Geotechnical Exploration, Inc.

Job No. 16-11251

Subject: **Response to City of San Diego Cycle Review Comments LDR-Geology: Project No. 508125, Cycle Issue 11**
Proposed Foxhill Residence
7007 Country Club Drive
La Jolla, California

Figure No. 11c
Job No. 16-11251

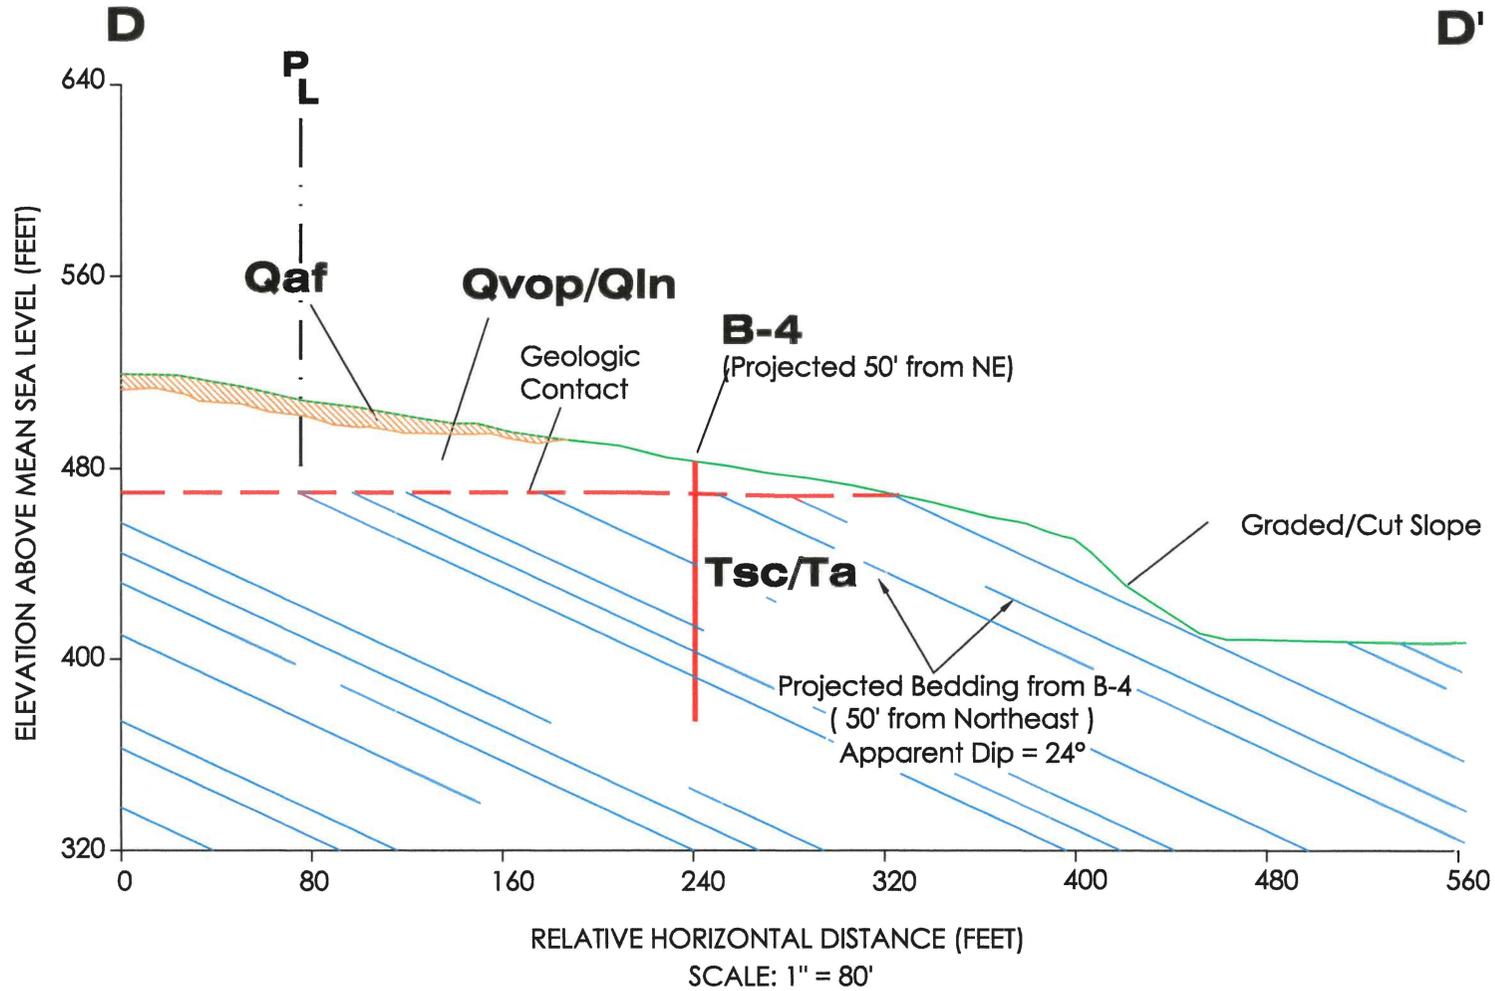
Issue No. 5: Provide geologic/geotechnical cross-sections representative of the site conditions and proposed grading. (Outstanding Issue from Cycle 2)

GEI Response: We have included geologic/geotechnical cross-sections representative of the site conditions and proposed grading from the referenced architectural and grading plans with this update letter as Figure Nos. IIa-b. In addition, we have included a revised geologic cross-section D-D' from our "Report of Preliminary Geotechnical and Geologic Investigation, Copley Press Residential Project," dated November 16, 2011, of the adjacent parcel (APN 352-300-04-00) and a portion of the subject site. Please, refer to Figure Nos. Ia-b for the geologic cross-section locations on the Plot Plans with Site-Specific Geology. Refer to Figure No. IIC for the revised Geologic Cross-Section D-D'.

*Excerpt from Geologic Hazards Map-
Sheet 29*

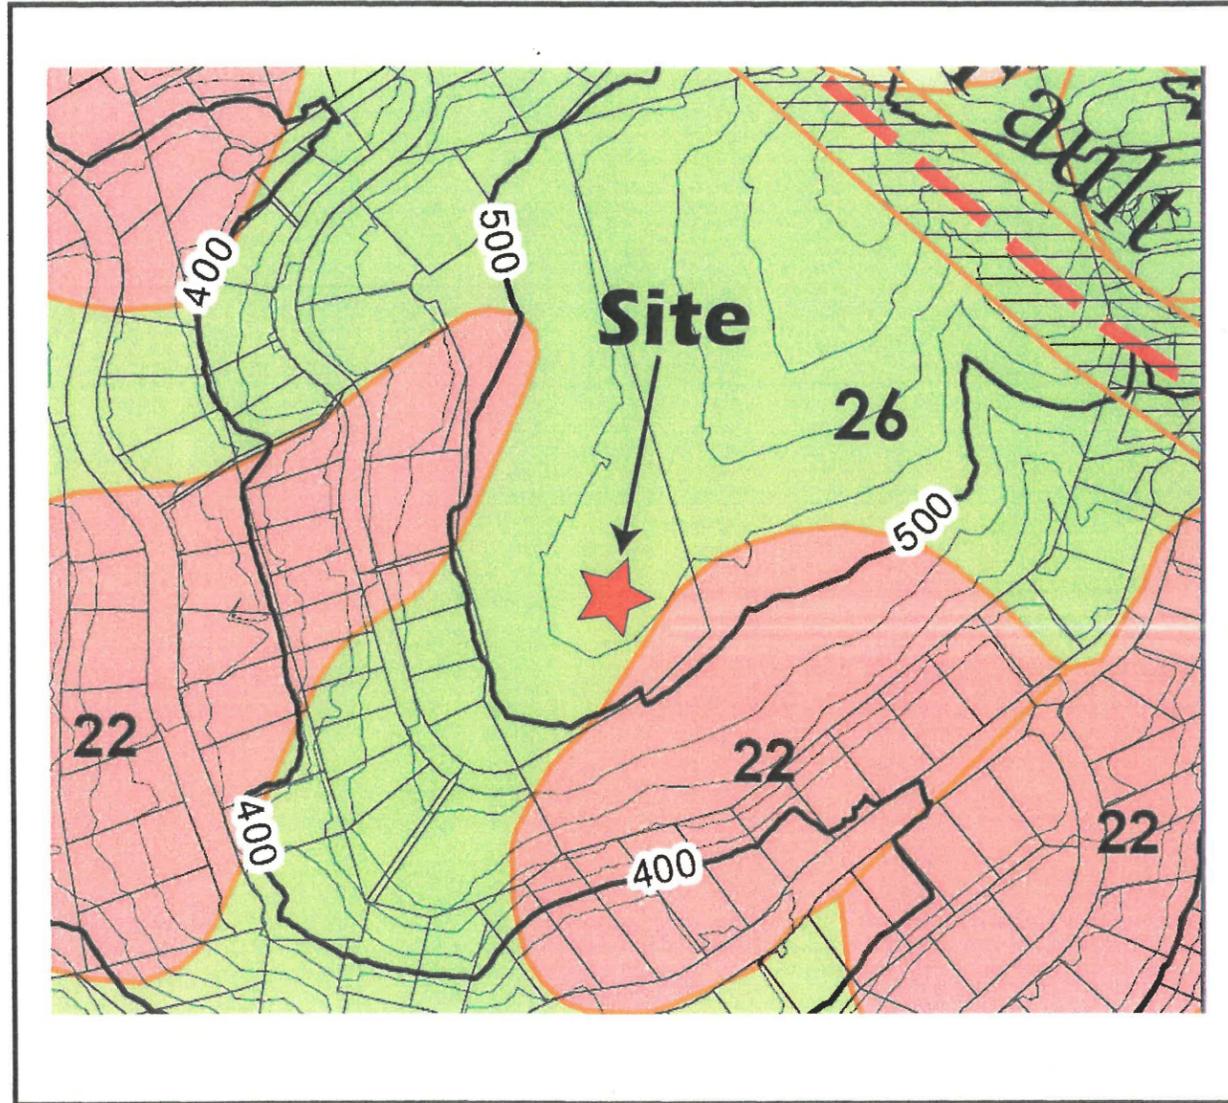
Issue No. 6: According to the San Diego Seismic Safety Study Geologic Hazard Maps, a portion of the access road for the guesthouse is located in geologic hazard category 22, indicating potential slope instability, possible or conjectured landslide. Clarify if the site or any portion of the site is located on or adjacent to a landslide. Provide the rationale and site-specific physical evidence used to support a determination regarding the presence or absence of landsliding at the site. (Outstanding Issue from Cycle 2)

GEI Response: We understand a portion of the proposed access road for the residence is located in Geologic Hazard Category (GHC) Zone 22. Based upon our recent and previous site exploration, downhole logging of a large diameter boring for our "Report of Preliminary Geotechnical and Geologic Investigation," dated November 16, 2011 (adjacent parcel), our geologic traverse across the site, review of the geologic map (Kennedy and Tan, 2008), review of the referenced City of San Diego Seismic Safety Study -- Geologic Hazards Map Sheet 29 and stereo-pair aerial photographs (4-11-53, AXN-8M-1 and 2), there are no known or suspected ancient landslides in the vicinity of the subject site. Please, refer to Appendix A for the Geologic Hazards Map and Legend.
